HISTORIC AND DESIGN REVIEW COMMISSION

HDRC CASE NO: 2022-478

COMMON NAME: ROW at Frio & W Commerce

TYPE OF WORK: Installation of public art APPLICATION RECEIVED: September 09, 2022

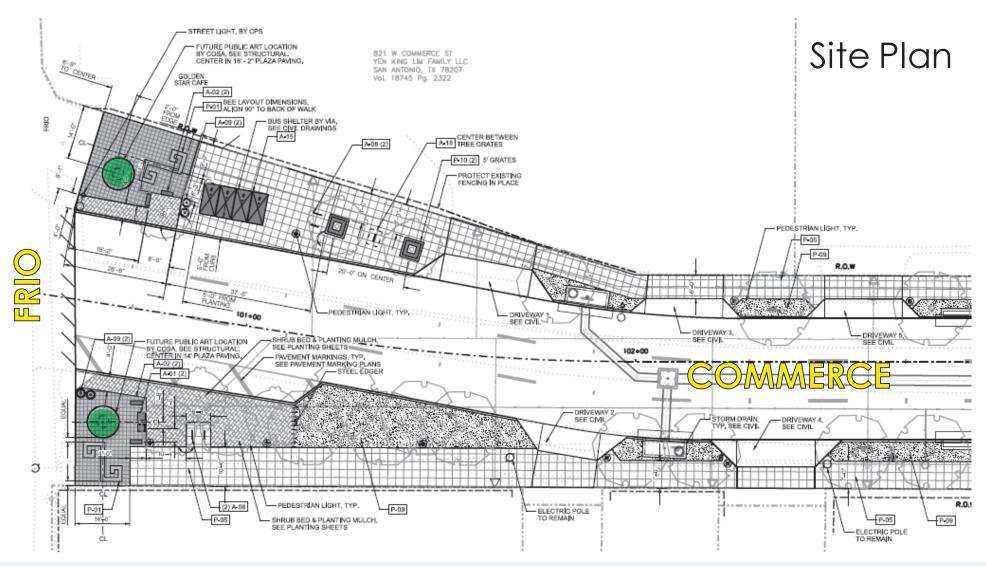
- b. PUBLIC ART: NORTHEAST CORNER The applicant has proposed to install one public art sculpture in the public right-of-way on the northeast corner of the N Frio & W Commerce intersection. The proposed sculpture will feature dimensions that are 10 feet in height and 8 feet in diameter and will resemble a kite. The proposed sculpture will feature an anti-graffiti coating and will sit on a concrete foundation that is two feet in height. Material specifications have not been provided at this time. The design of the artwork is based on community engagement completed by The Department of Arts & Culture and attendance at the Public Art Committee and San Antonio Arts Commission meetings. The engineering fabrication, and installation of the sculpture will be managed by a contractor through the Department of Arts & Culture in coordination with the artist. The installation is scheduled to be completed in Summer 2023. Staff finds the proposal generally appropriate but finds that the applicant should submit final material specifications to staff for review.

- c. PUBLIC ART: SOUTHEAST CORNER The applicant has proposed to install one public art sculpture in the public right-of-way on the southeast corner of the N Frio & W Commerce intersection. The proposed sculpture will feature dimensions that are 10 feet in height and 8 feet in diameter and will resemble a top. The proposed sculpture will feature an anti-graffiti coating and will sit on a concrete foundation that is two feet in height. Material specifications have not been provided at this time. The design of the artwork is based on community engagement completed by The Department of Arts & Culture and attendance at the Public Art Committee and San Antonio Arts Commission meetings. The engineering fabrication, and installation of the sculpture will be managed by a contractor through the Department of Arts & Culture in coordination with the artist. The installation is scheduled to be completed in Summer 2023. Staff finds the proposal generally appropriate but finds that the applicant should submit final material specifications to staff for review.

- i. That the applicant submits material specifications to staff for review and approval based on findings b through c.
- ii. ARCHAEOLOGY The project shall comply with all federal, state, and local laws, rules, and regulations regarding archaeology, as applicable.
